# THE BULLETIN OF THE BEAUX ARTS INSTITUTE OF DESIGN

MARCH, 1938

# CRITIQUE

#### **CRITIQUE**

FIRST MEDAL-P E. FALKENSTEIN

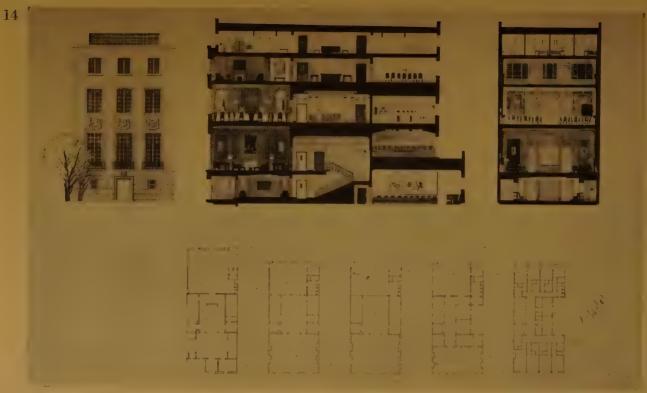
An excellent, clear cut plan, more conventional than the preceding, but also more adaptable to normal city conditions. The building is conservative in arrangement and design, and suitable for a Club. The entrance lobby is ample, giving easy access to coatroom, toilet room, reception room, and business counters. The stairs are well placed and the ground floor opens through to the tap room. The two other principal rooms, the dining room and the lounge, are placed across the front of the building on the second and third floors. The second floor is entirely devoted to dining areas, including the main dining room and the private dining rooms, with services between. The third floor contains lounge and game rooms and the fourth floor contains the bedrooms and the library, which is well placed in an isolated position at the front of the building. Kitchen and service facilities are ample. The character is excellent and the façade expresses well the volumes which are behind it.

SECOND MEDAL-C.B. WILLITS

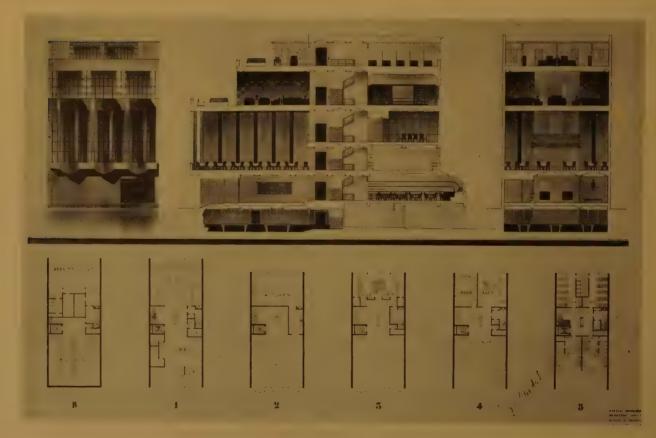
A conservative scheme with good interior volumes and excellent progression from one interior space into another, even though the central stair tends to block off the passage from front to rear on the first and second floors. The elevation is simple and in good character.

SECOND MEDAL-B. ROMBERGER CLASS A PROJET III-AN ALUMNI CLUB

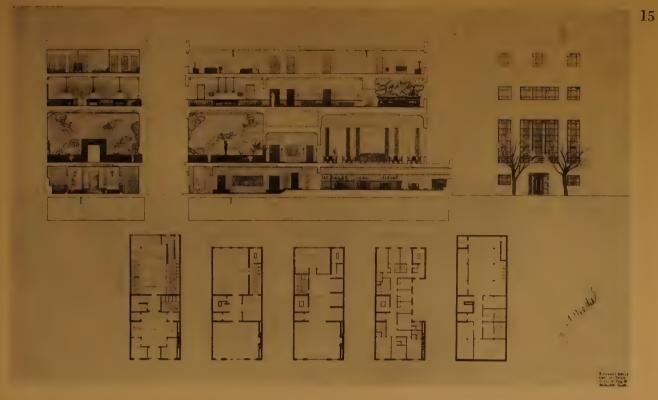
B. Romberger, Princeton University, Second Medal: An extremely simple plan in which the principal rooms are again well placed. The kitchen at the rear of the second floor is an efficient arrangement although it cuts off light which might have been used for public rooms. The interior volumes are less carefully studied in their relation to one another than in the examples previously mentioned. The interior decoration is rather severe and mechanical. The elevation is also severe, but has distinct elements of strength.

SECOND MEDAL-R. C. KOELLE

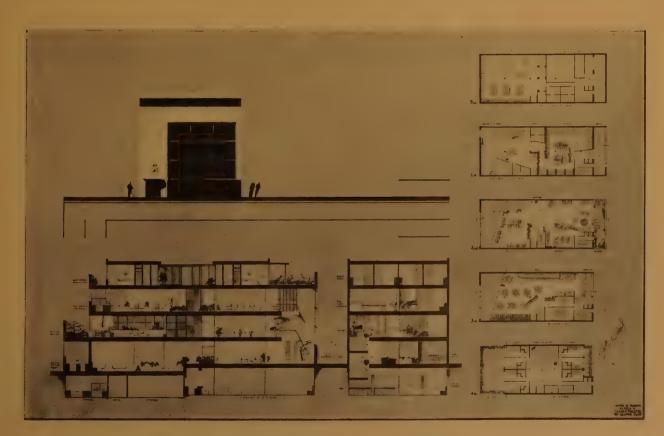
A straightforward plan with the principal rooms well placed and in good spatial relation to one another. The elevation was less carefully studied.

SECOND MEDAL-J. D. MURPHY CLASS A PROJET III-AN ALUMNI CLUB

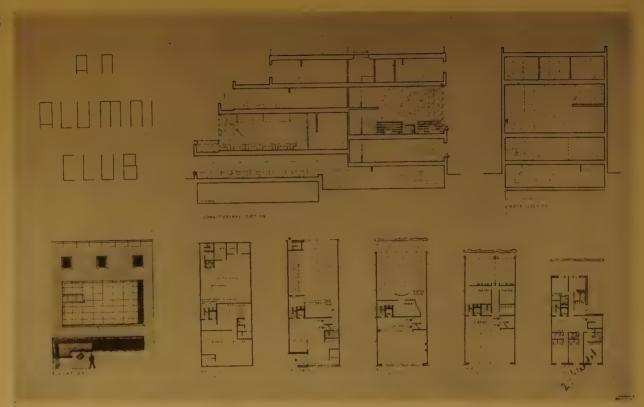
An unusual scheme which was awarded second medal for its originality. All the floors from the first to the third open upon a well back of the large opening at the front of the building. It is doubtful whether this arrangement would in fact be agreeable as the units cannot be isolated from one another. The drafts from the front door would be felt in the lounge and dining room and the noise of the dining room would be heard on the floors below. The elevator and main stairs, opening

directly into the principal rooms, would be subject to similar criticism. The most interesting feature of the scheme is the arrangement of the lounge with ventilation and light from both ends.

SECOND MEDAL—J. A. BORRECA

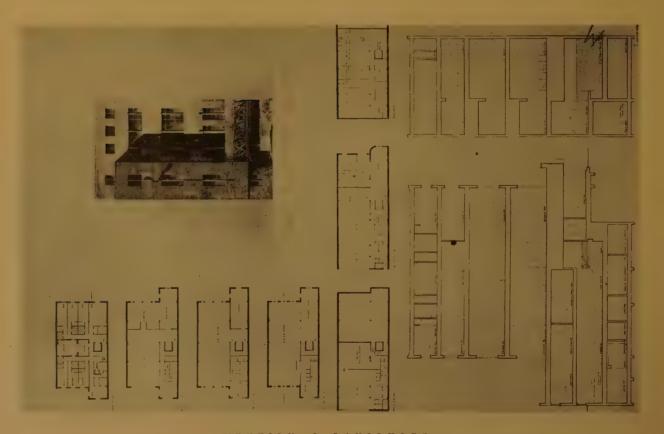
This is a clear plan in which the principal rooms are well placed. Advantage is taken of setbacks at the rear of the building to form attractive terraces. The placing of the library on a balcony in the lounge is questionable. It lacks the necessary quiet and seclusion. The elevation of this project is not particularly pleasing in its proportions; the accident occasioned by the library balcony is unfortunate. The unequal emphasis resulting from expressing the small openings in black, and the large opening in white, is somewhat misleading.

FIRST MENTION—F. H. NORRIS

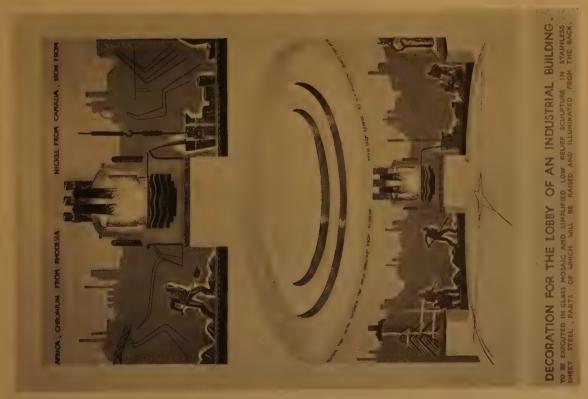
One of the more successful solutions from the point of scale is that submitted by F. H. Norris of John Herron Art Institute. The spectator approaching this mural finds himself comfortably related to the scale of the decoGEOFFREY NORMAN

ration which occurs at eye-level. The upper and larger area of the wall is reserved for huge symbolic forms suggestive of the main theme. This solution illustrates a happy and interesting contrast which is achieved in playing one complimentary motif against another, one complimentary area against another, one color against another. Moreover, the lower portion is devoted to the literal treatment of the uses of steel and is depicted pictorially, whereas the large masses are reserved to depict symbolically the forces that enter into the production of steel.

FIRST MENTION PLACED-J. H. HUDSON
CLASS B PROJET IV—A BANK INTERIOR

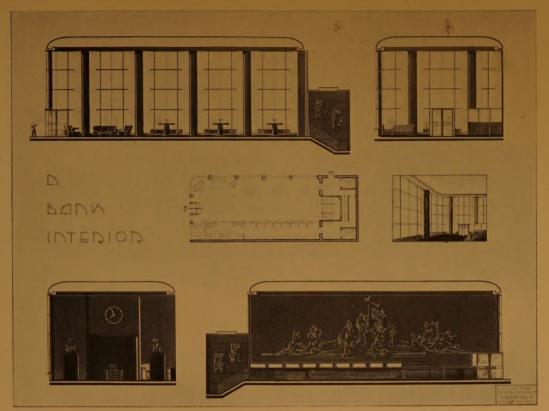
The design submitted by J. H. Hudson, Oklahoma Agricultural and Mechanical College, shows a practical plan coupled with an interesting and simple decorative wall treatment recalling a textile pattern.

FIRST MENTION PLACED-J. L. THORNE

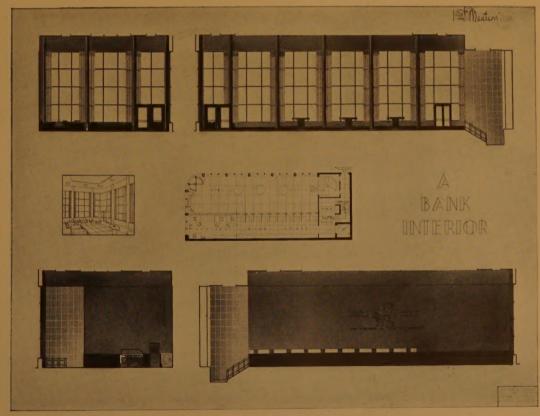
That submitted by J. L. Thorne of Pennsylvania State College, while effective, devotes unnecessary space for the public to the detriment of banking operations.
